LAND OF SUSHI

COTTONWOOD WATER & SANITATION CONSTRUCTION PLANS

AUGUST 2023

UTILITY SITE PLAN

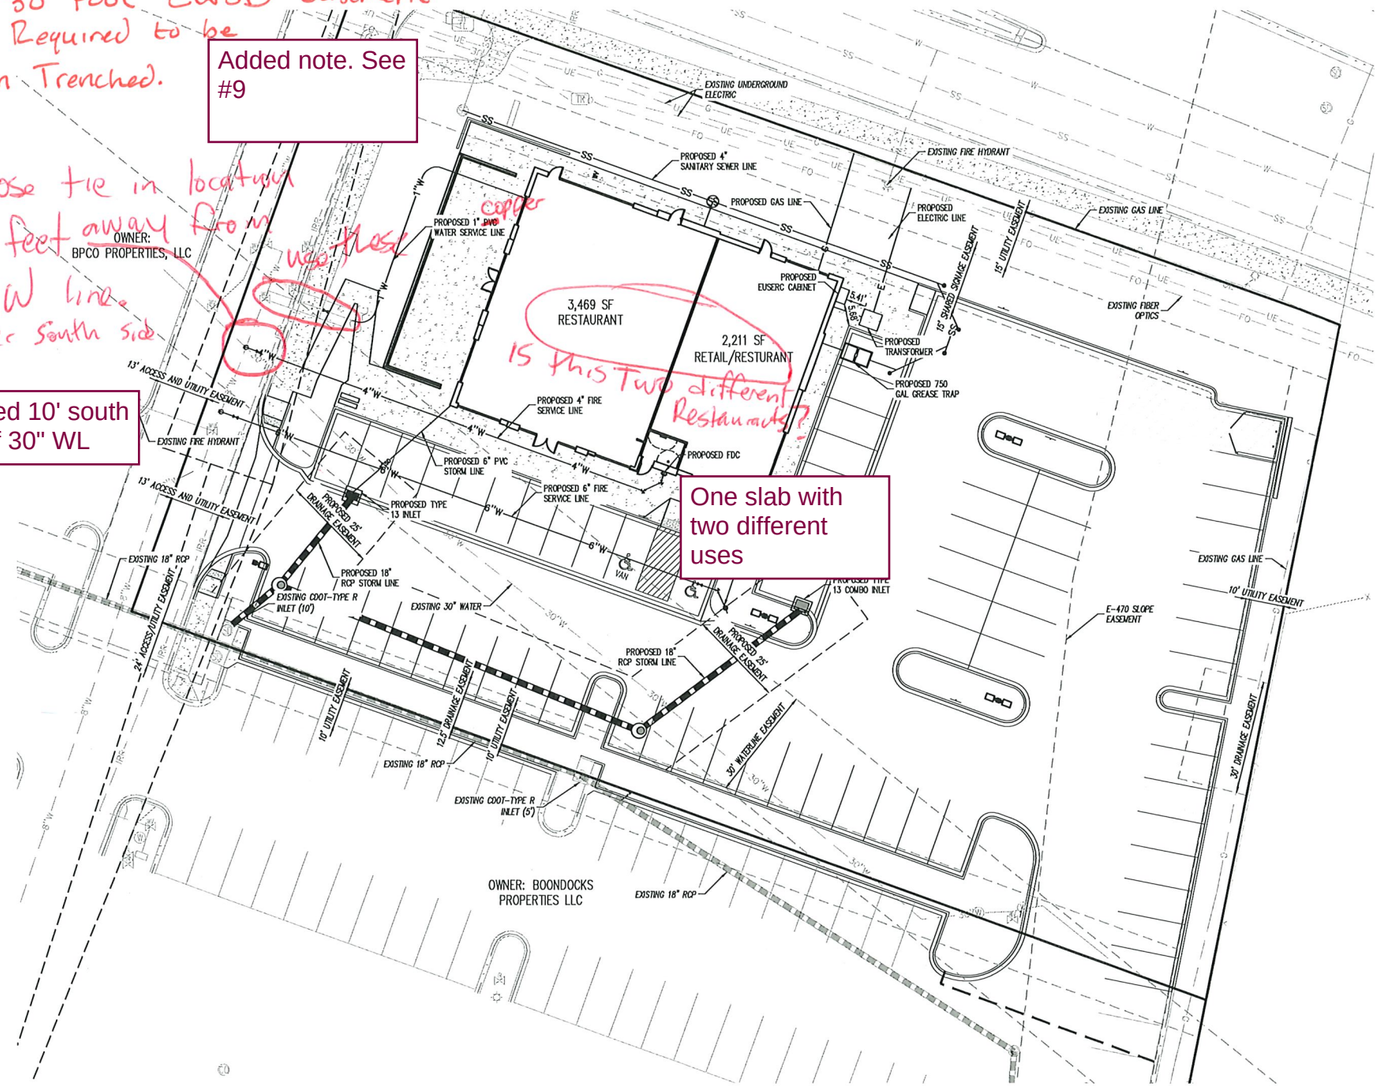
All Utility Installations within the Ex. 30 FOOT CWSD Easement are Required to be Open Trenched.

Repeat Comment(CRL) Should be on all Utility Sheets.

Choose tie in location ten feet away from 30" W line. Prefer South side

Added note. See #9

Moved 10' south off of 30" WL
